INDICATIVE
DRAWING DETAILS T/F/16/16.

FOR DOUBLE HUNG SASHES,
BUT DOUBLE-GLAZED.

BOX SASH WINDOW - Scale 1:2

FLUSH CASEMENT WINDOW

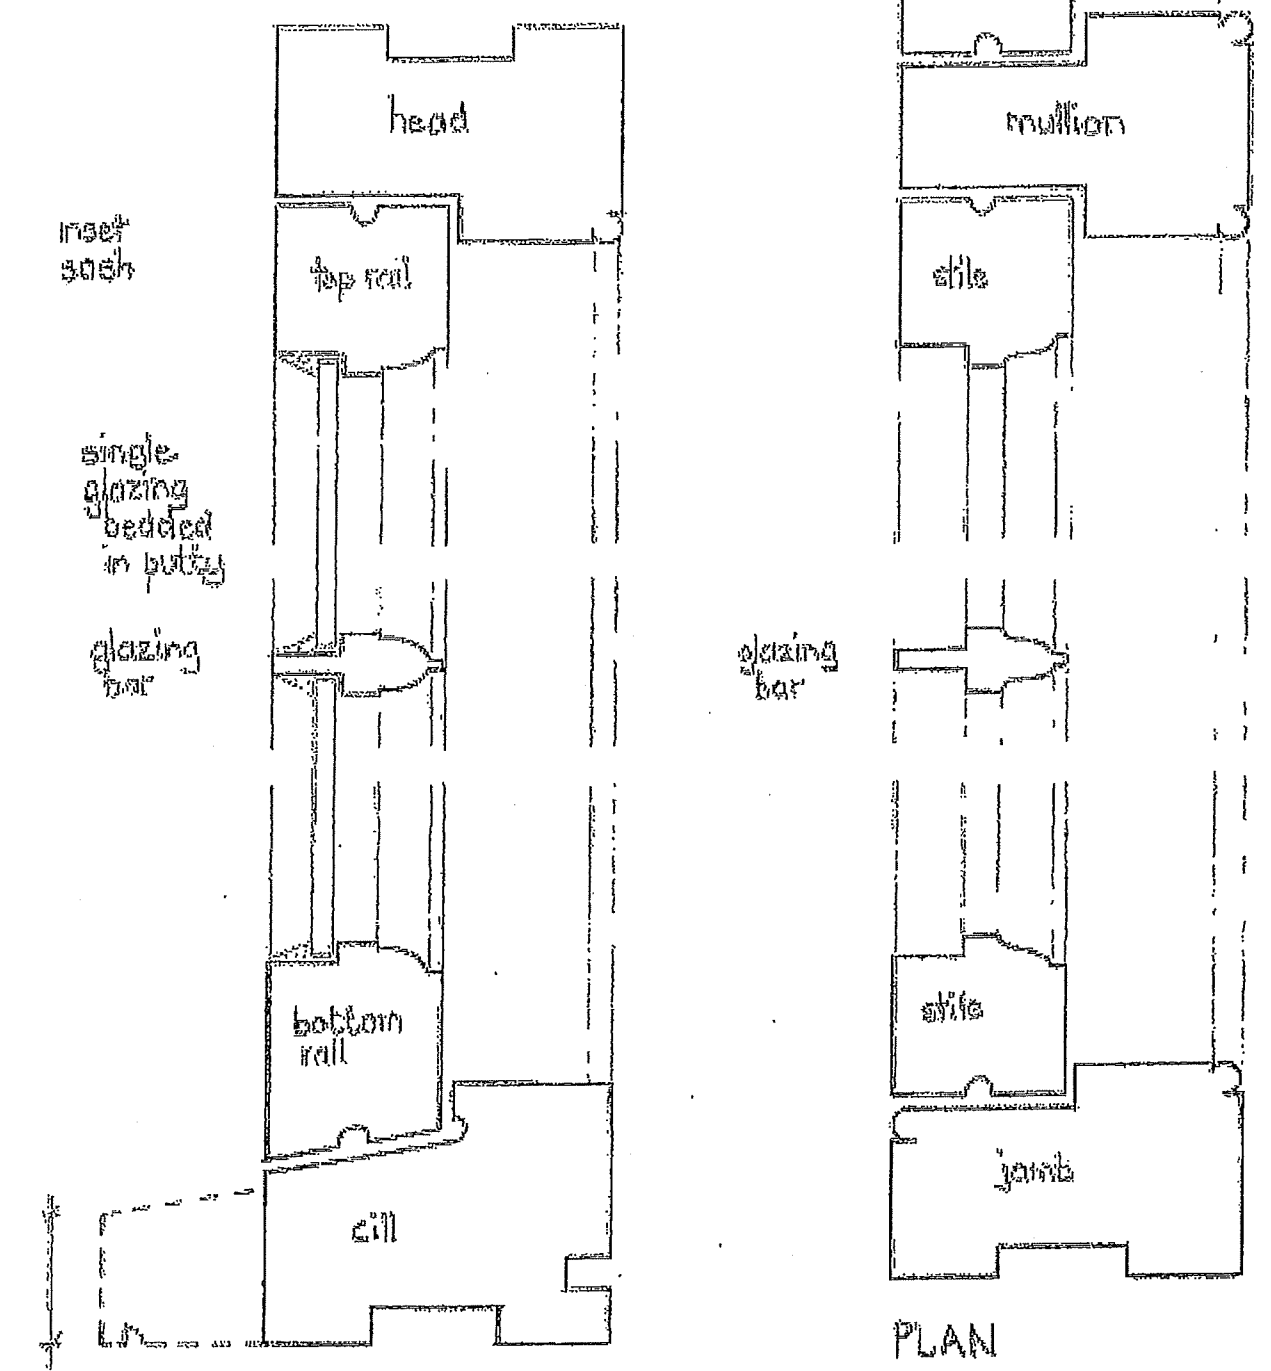
~~SINGLE GLAZED~~ DOUBLE-GLAZED Scale 1:2
REQUESTED.

* LAMB TONGUE MOULDING ALTERNATIVE GLAZING BARS THE SUGGESTED DETAIL FOR BROADLANDS. BUT WITH EXTENDED WEATHERED SILL.

WINDOW OPENINGS IN WEATHERBOARD

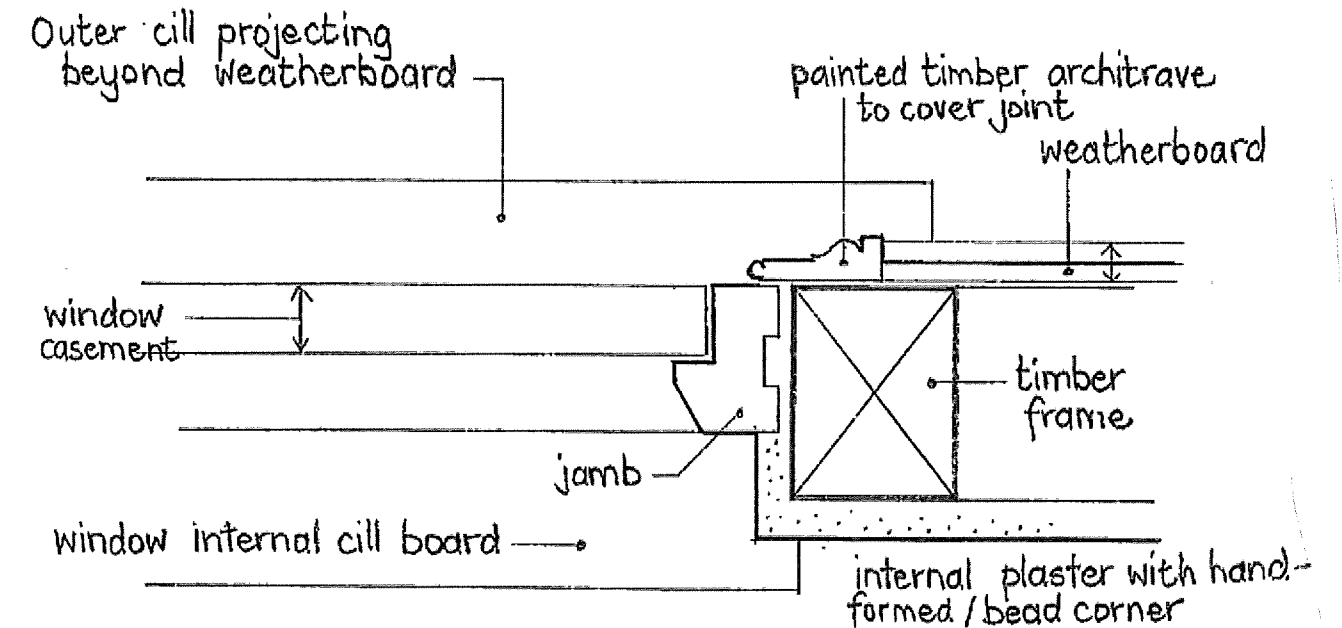
NOT APPLICABLE.

CHOSEN DETAIL TJP/10/2024
SIDE CASEMENT WINDOWS
ELEVATIONS

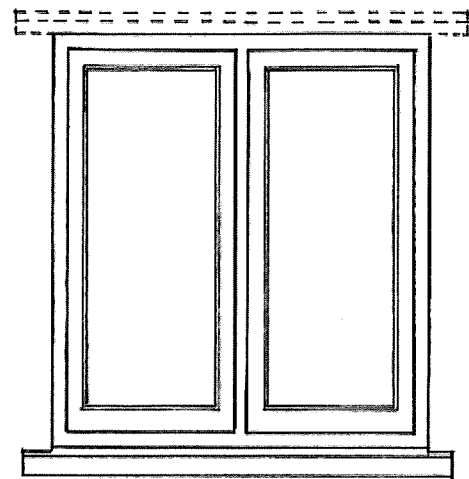
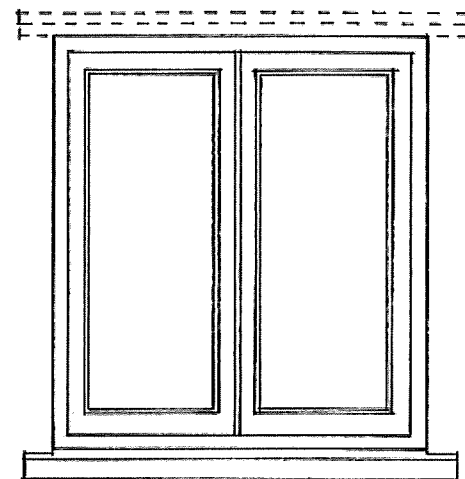
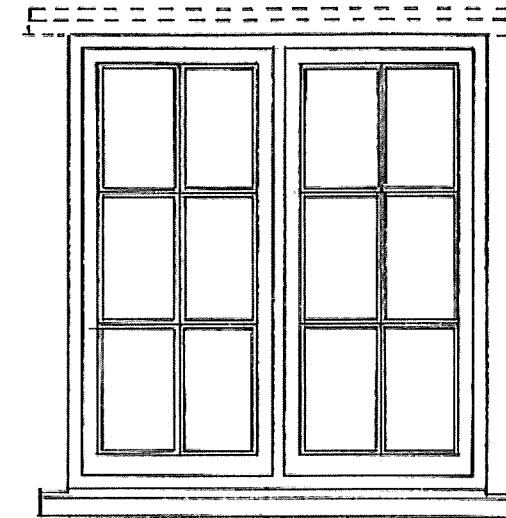
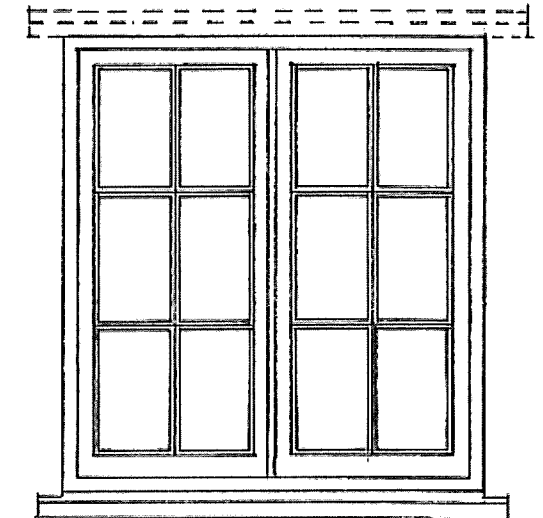
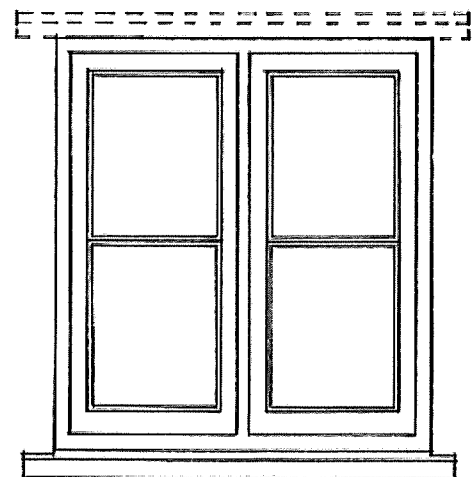
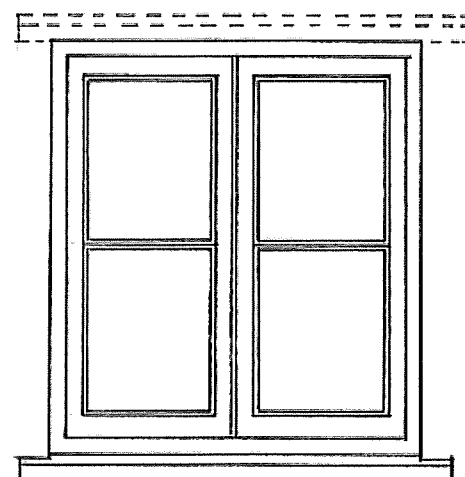
DETAILS TO BE FINALISED
AND AGREED SUBJECT
TO CONDITIONING AS
NECESSARY.
